ATTACHMENT B

MARKED-UP TECHNICAL SPECIFICATIONS

Attachment 2.1

Rev. 8

Fig.V-1 Dosimeter Locations for Stations near HBPP

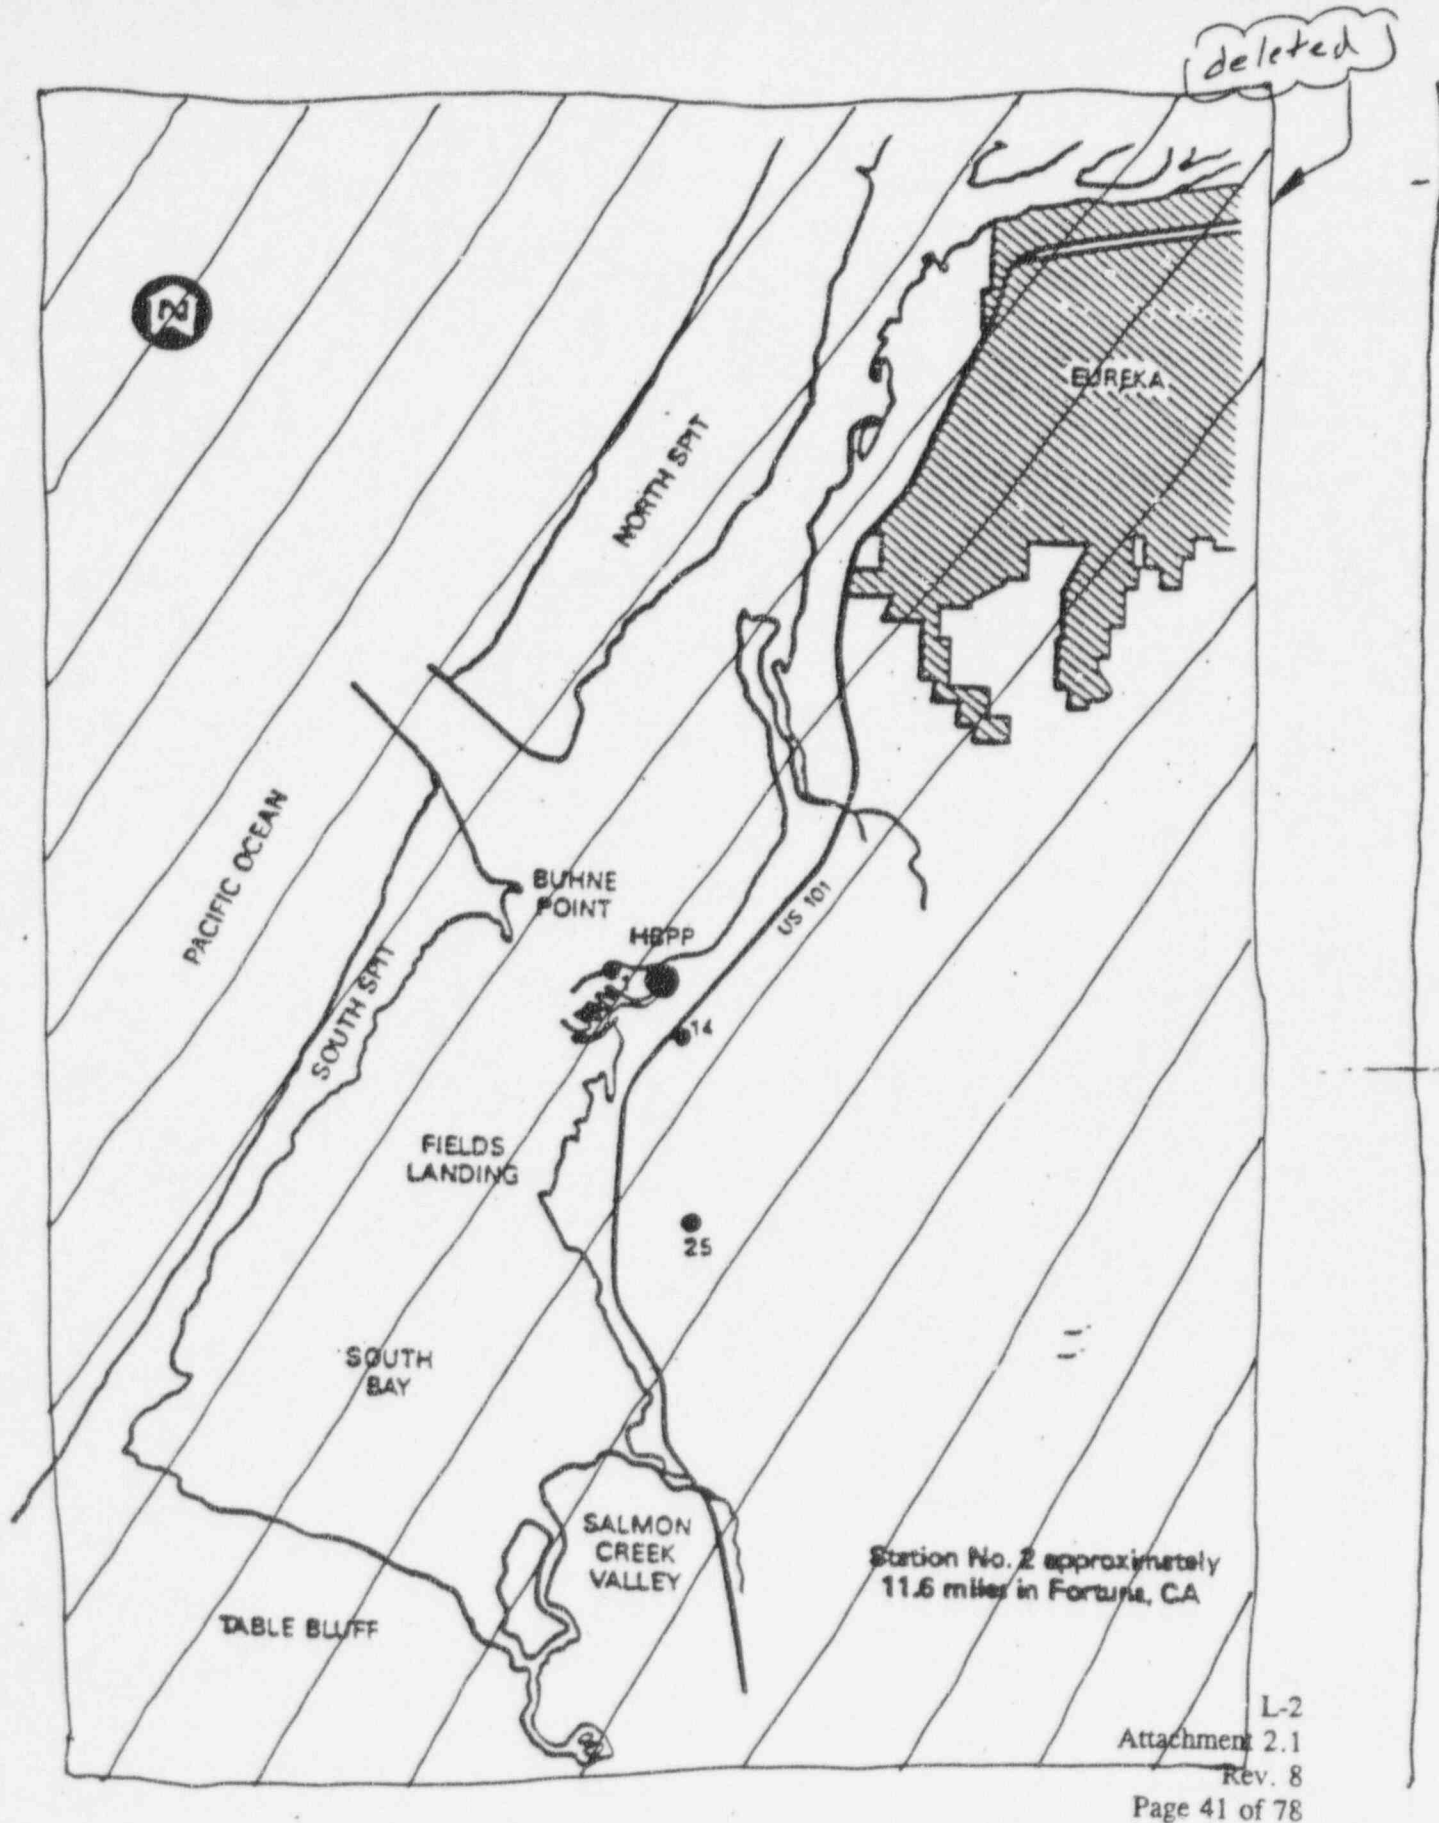
Deleted (handwritten note with arrow pointing to V-12)

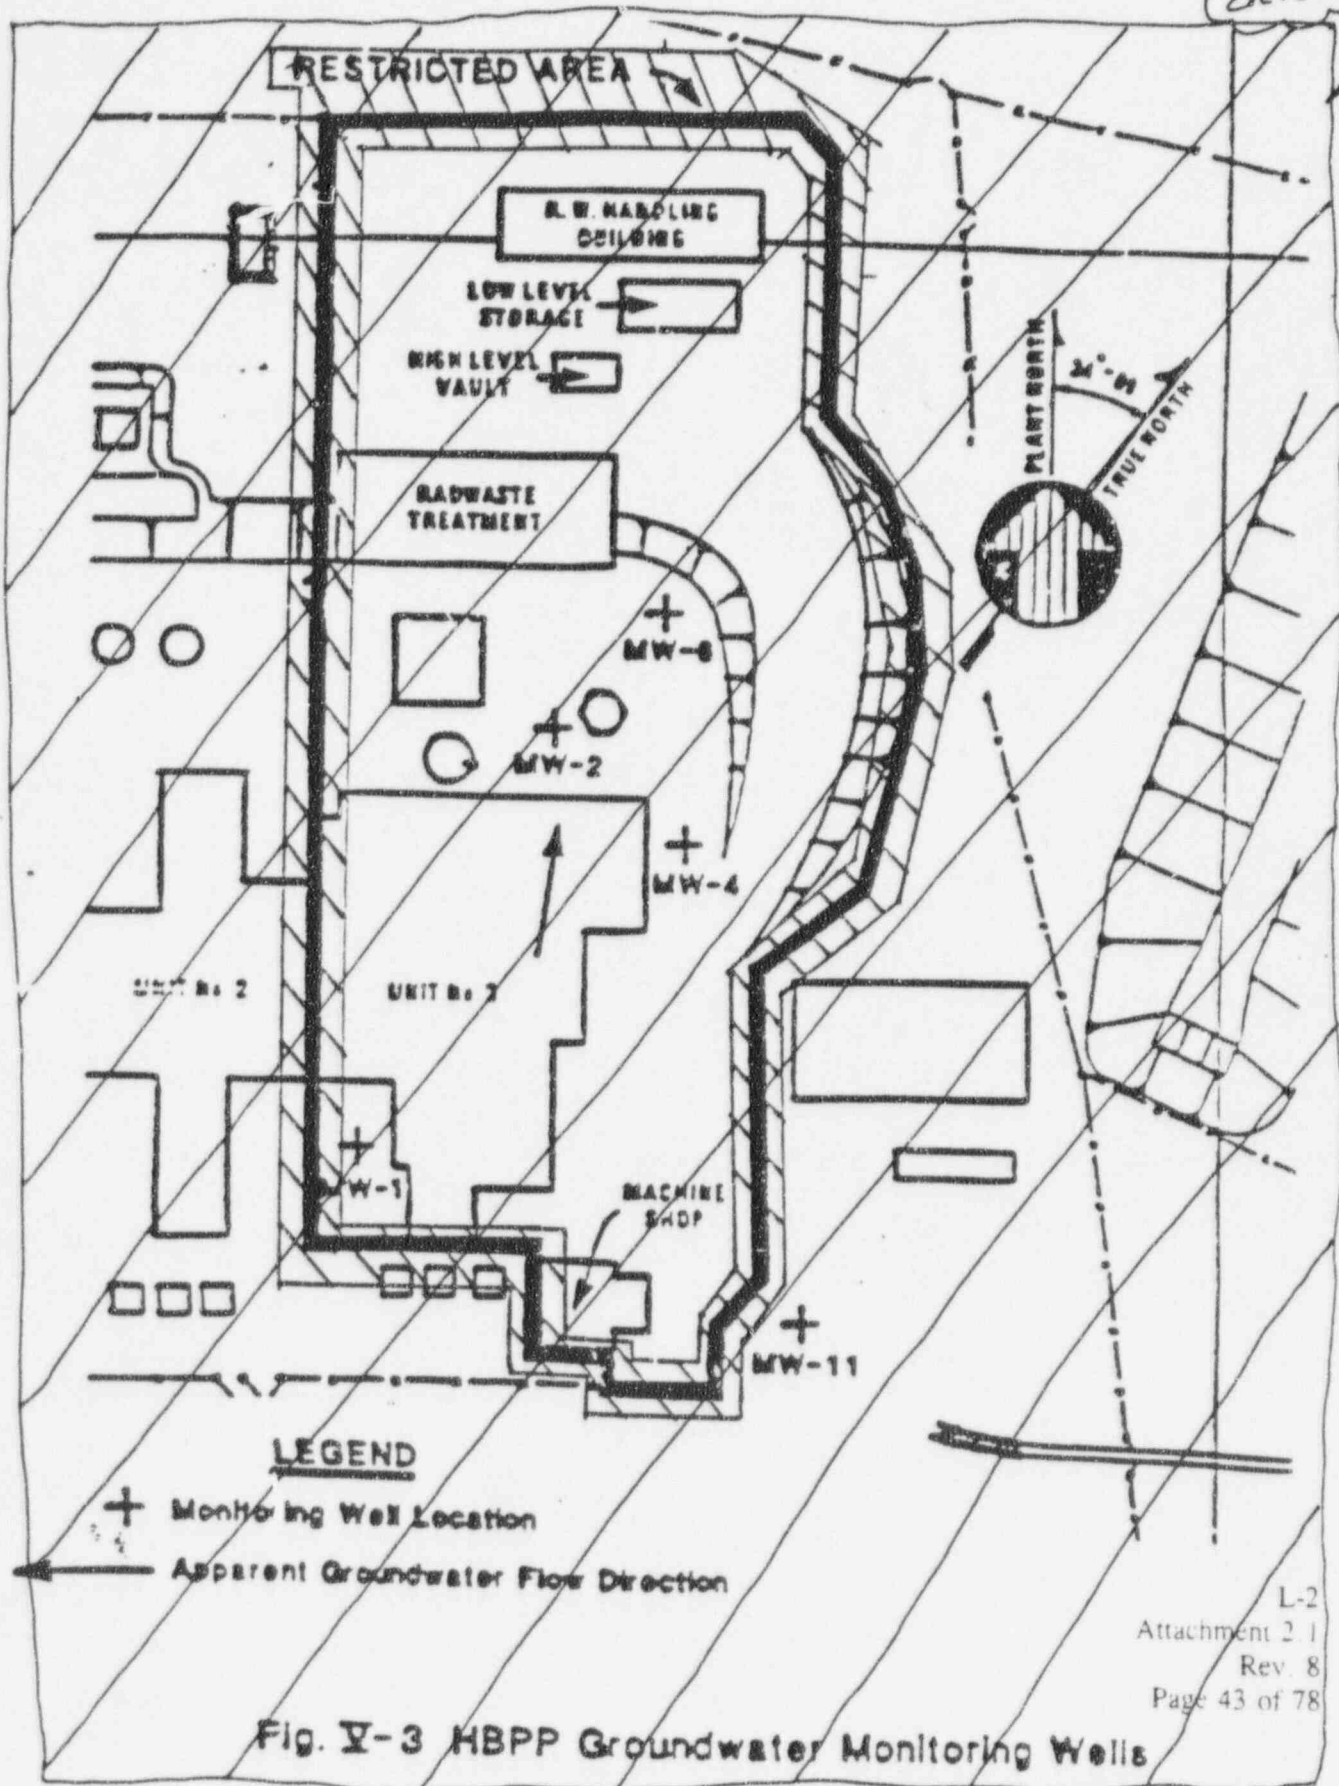
deleted
